ADDENDUM NO. 1

RE: Item #3, February 17, 2016 Letting - IM 0901(162)14, P 014A(11)8, PCN 020U, 0217, Lawrence County - Reconstruct Interchange, Reconfigure Ramps, & Reconfigure Service Road

PLANS: Please destroy sheets A2, A3, A5, B2, B5, B6, B7, B9, B10, B43, B62, B63, B71, B72, C2, C5, C8, D7, E71, F2, F7, and L2 and replace with the enclosed sheets, dated 1/28/16, 1/29/16, 2/1/16, 2/2/16, 2/3/16. Sheet B15A was added.

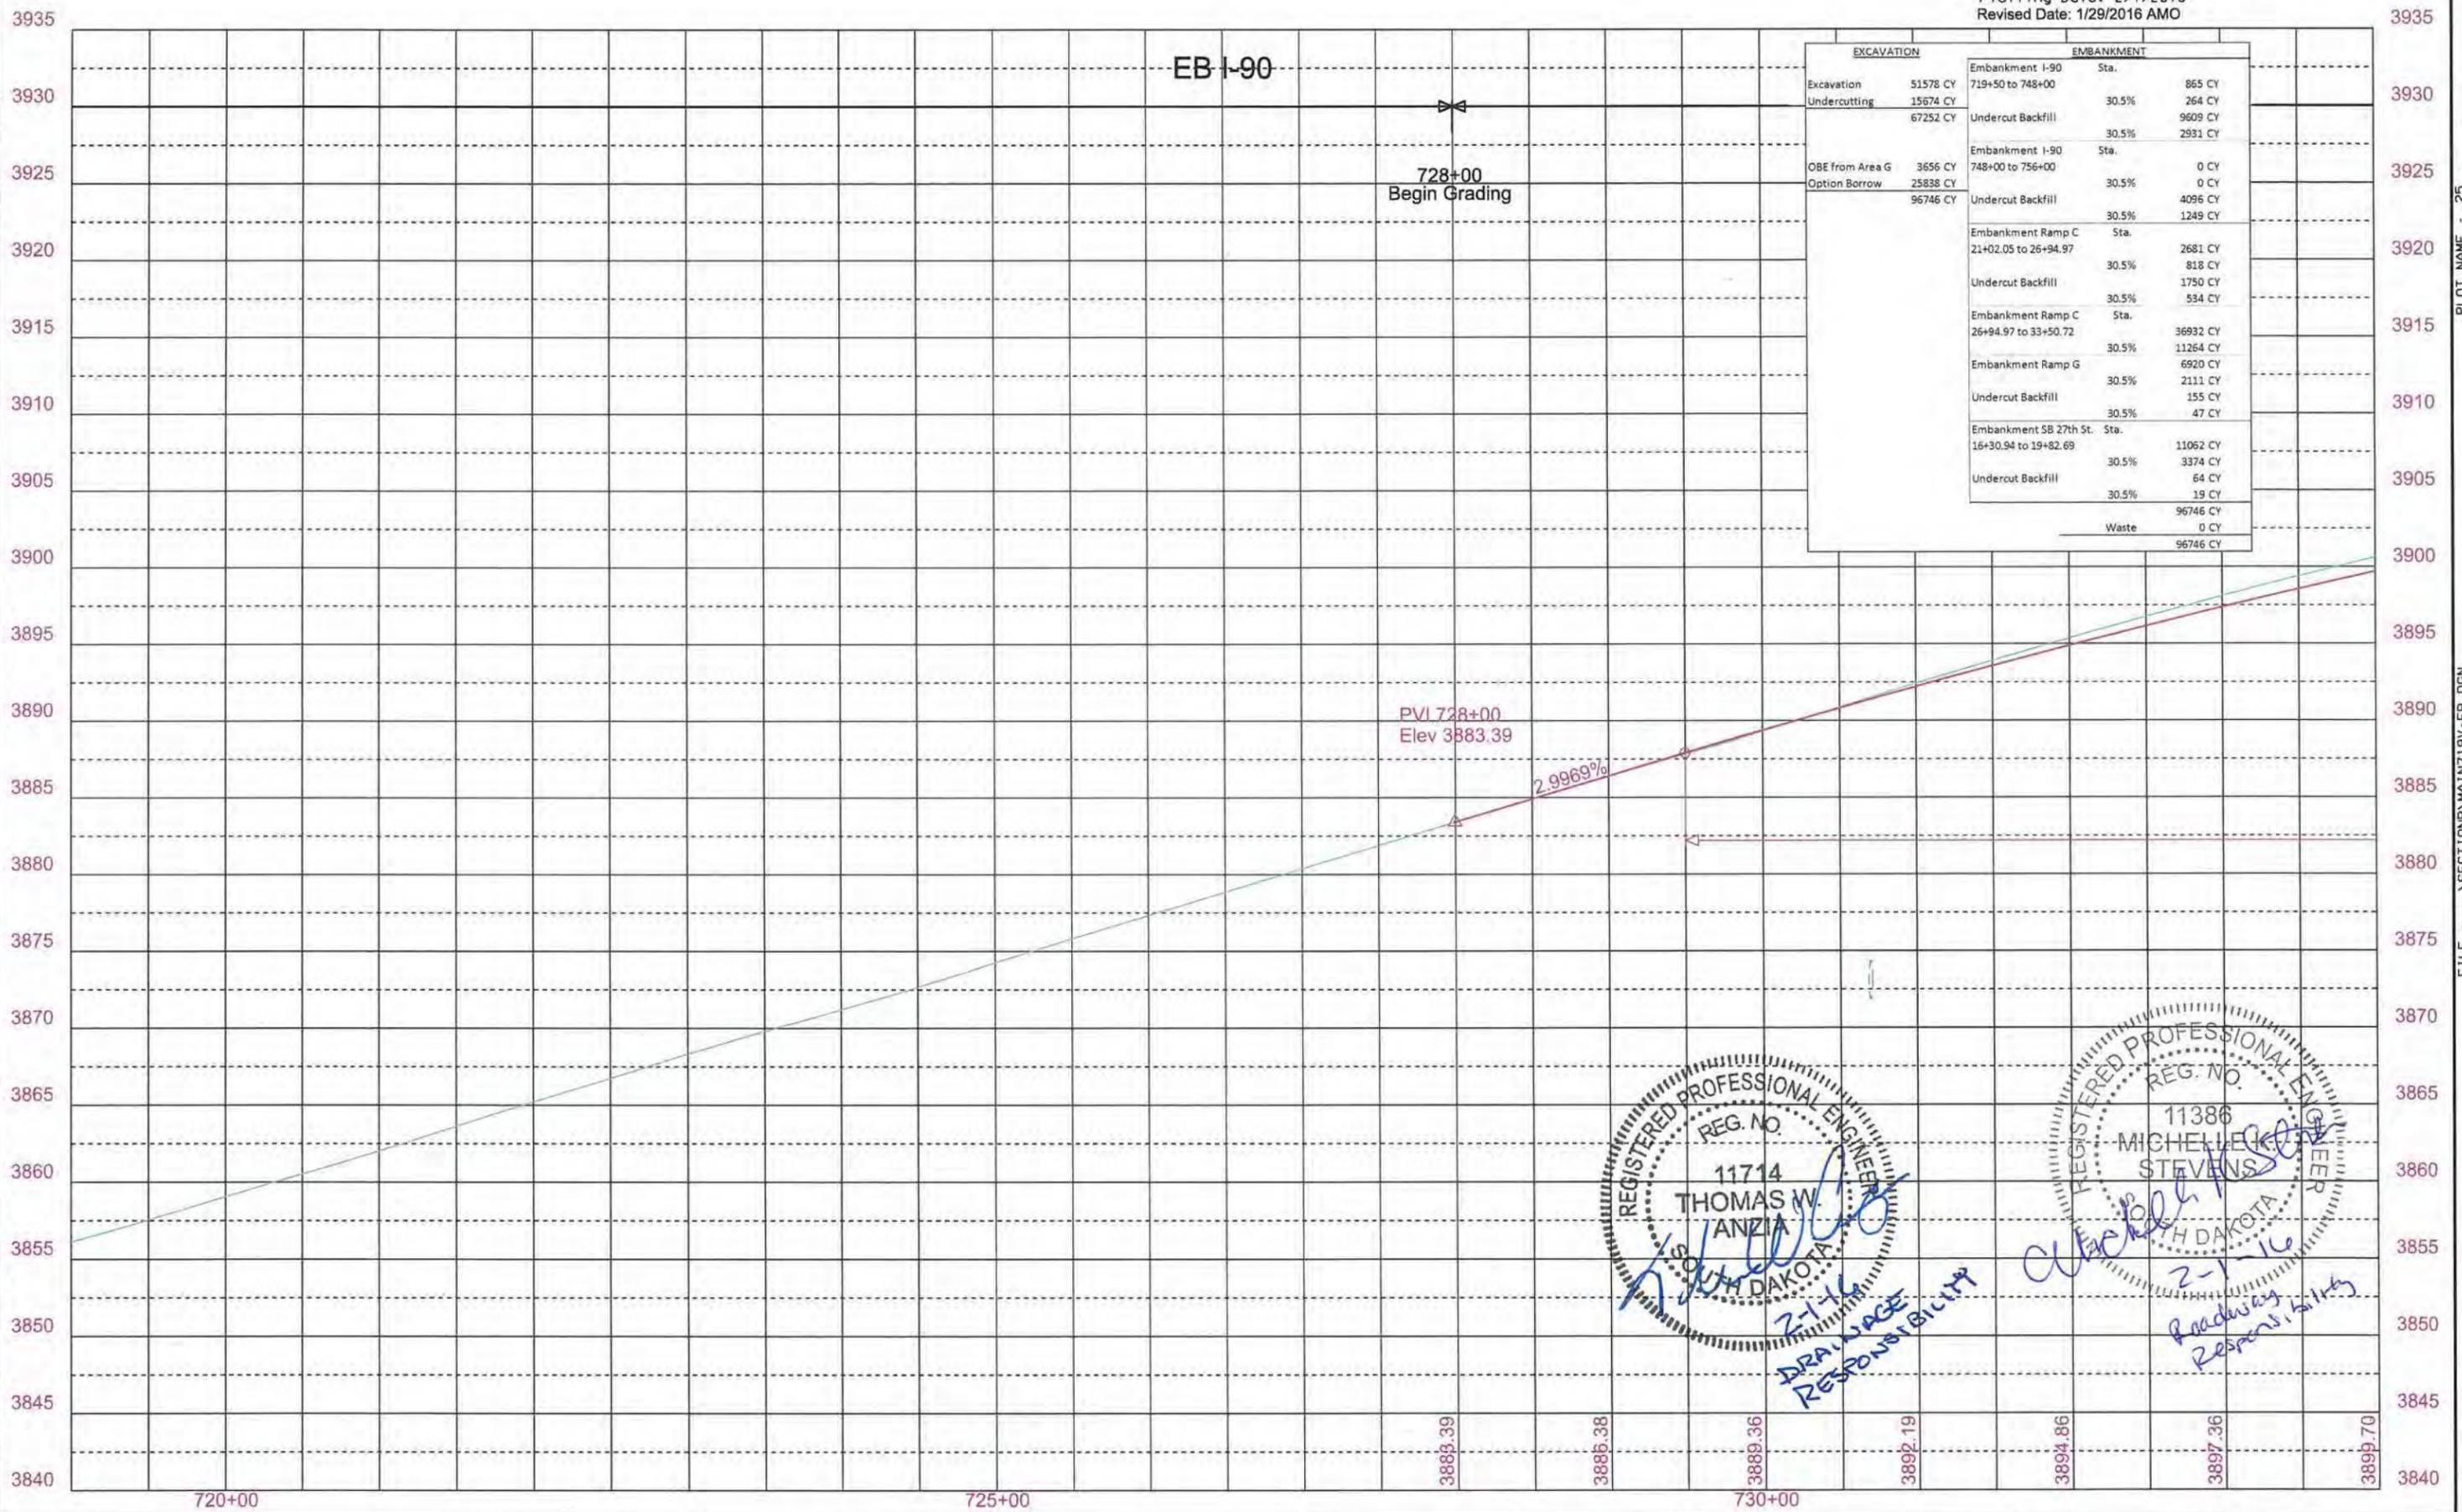
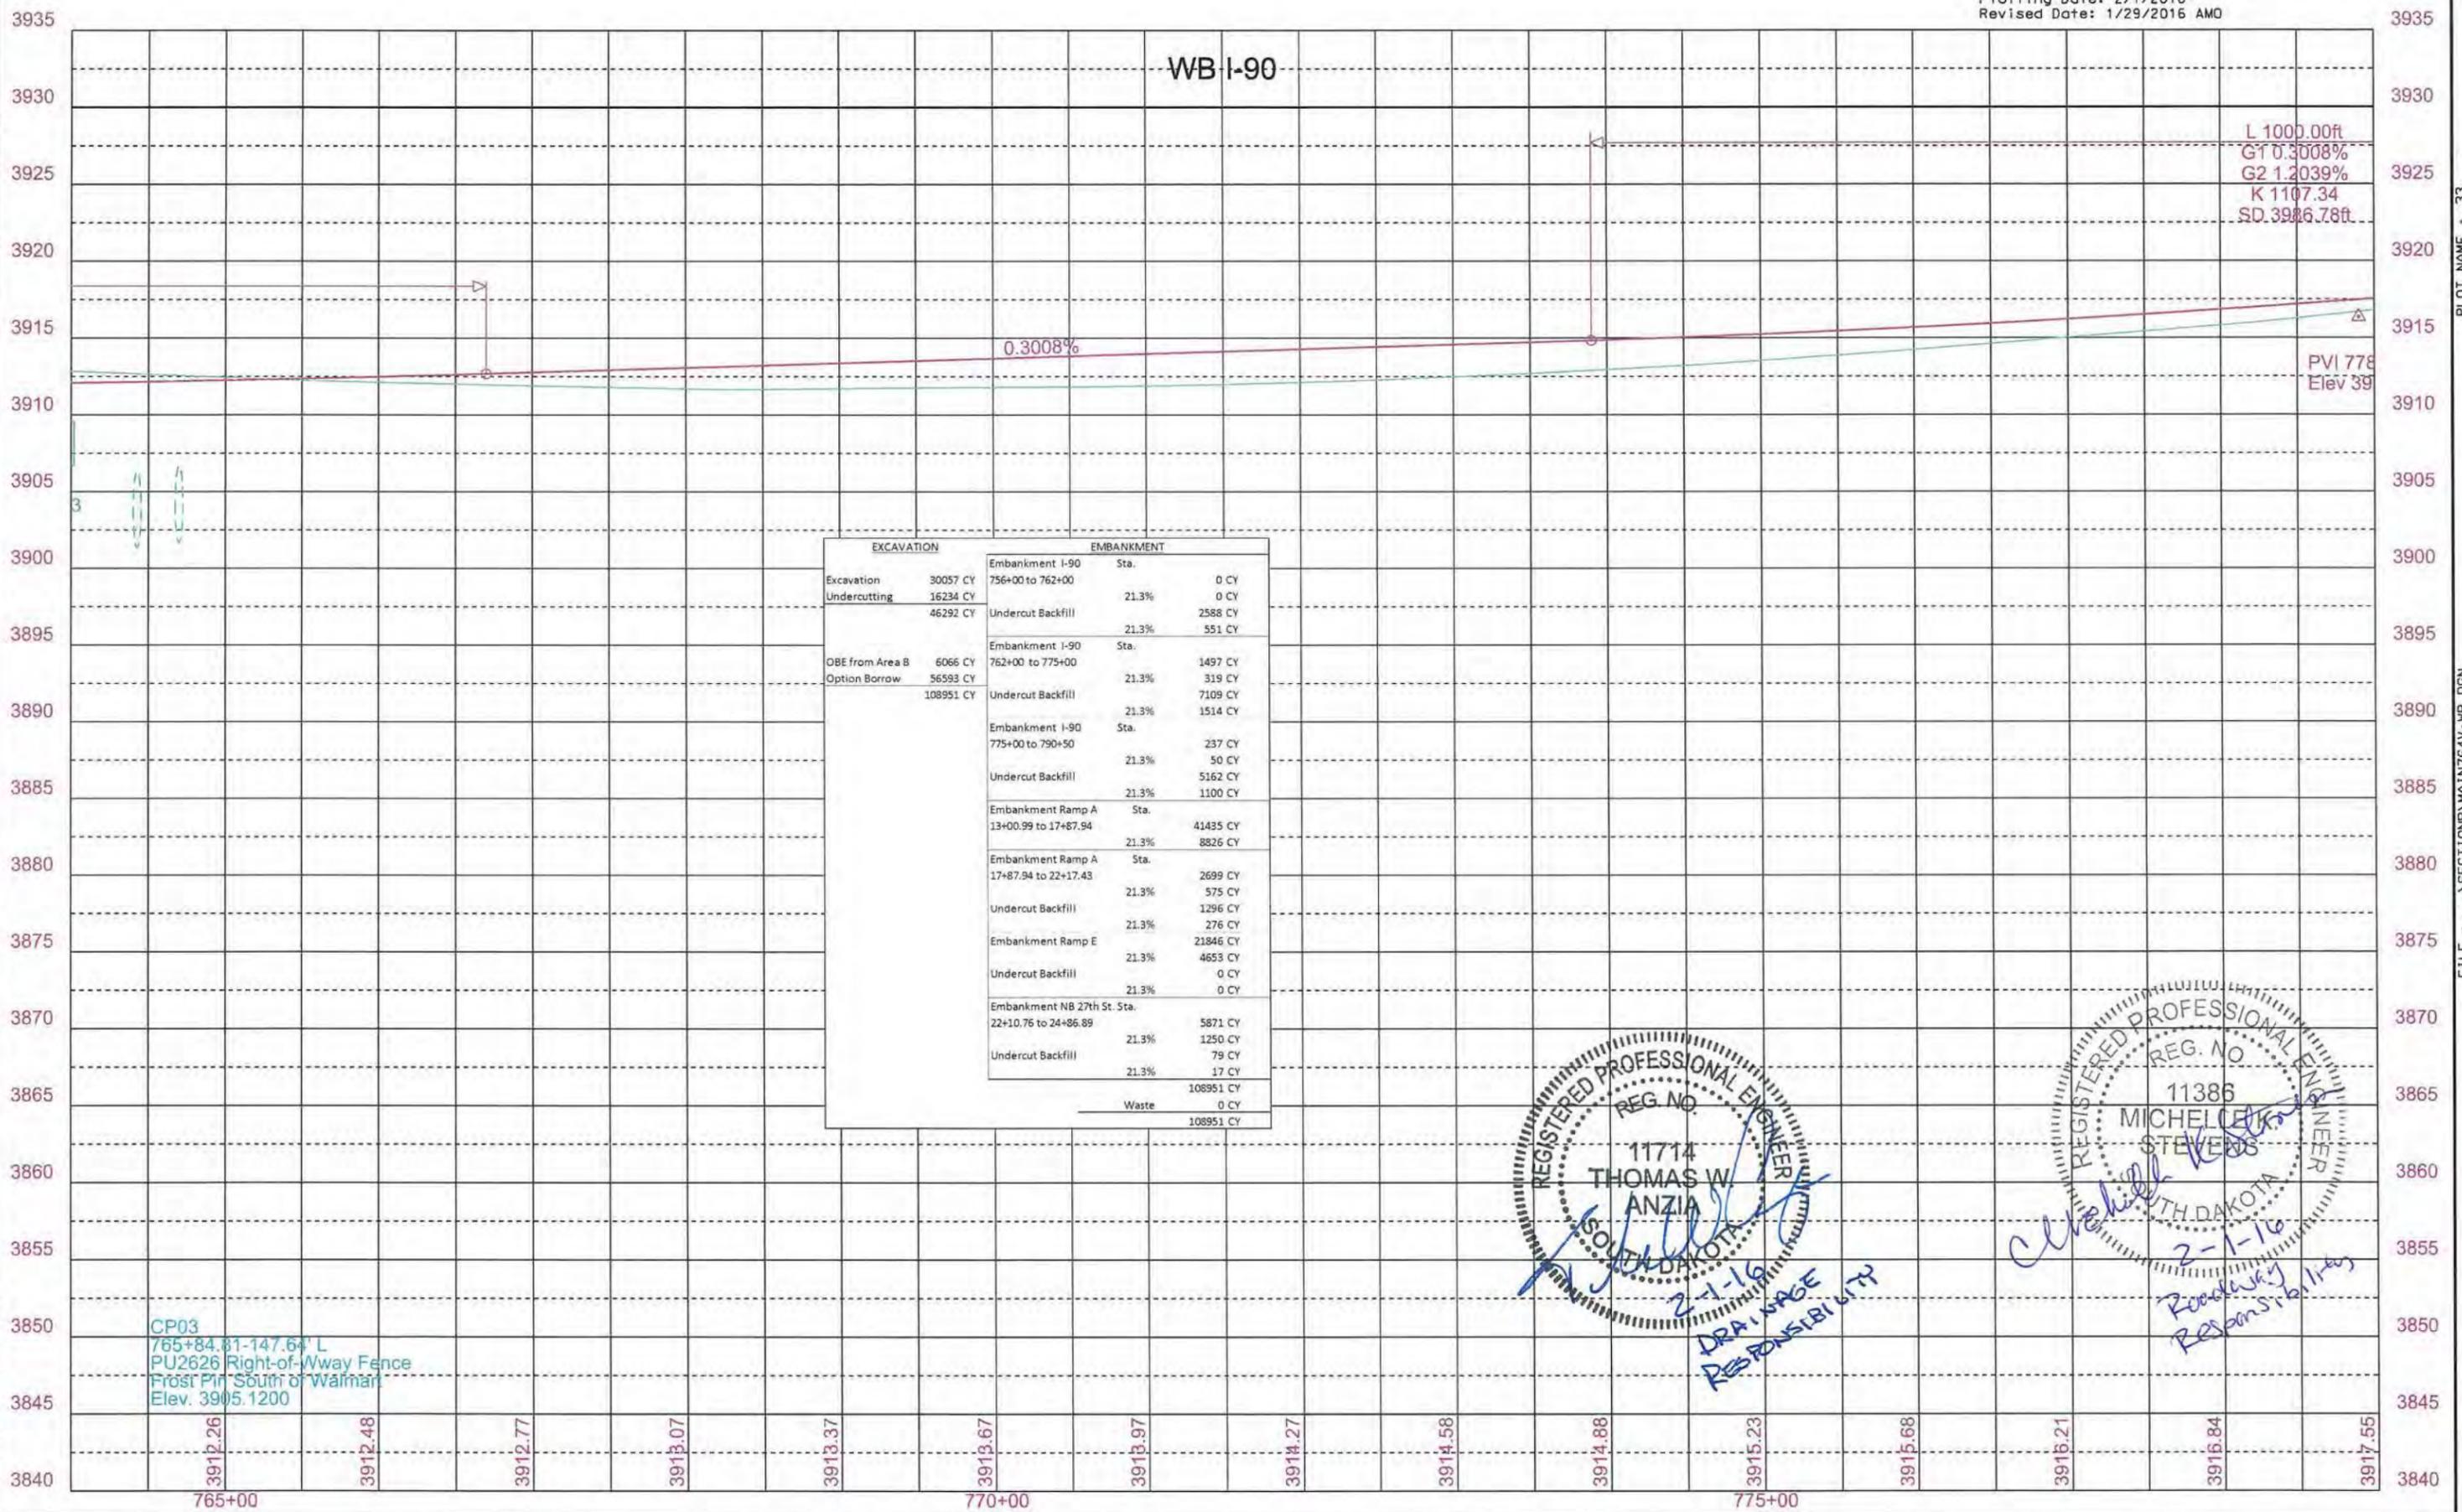
- Sheet B43:** Typical Section for Stationing for Undercutting was updated.
- Sheets B62, B63, B71 & B72:** Profile for Stationing for Undercutting was updated.
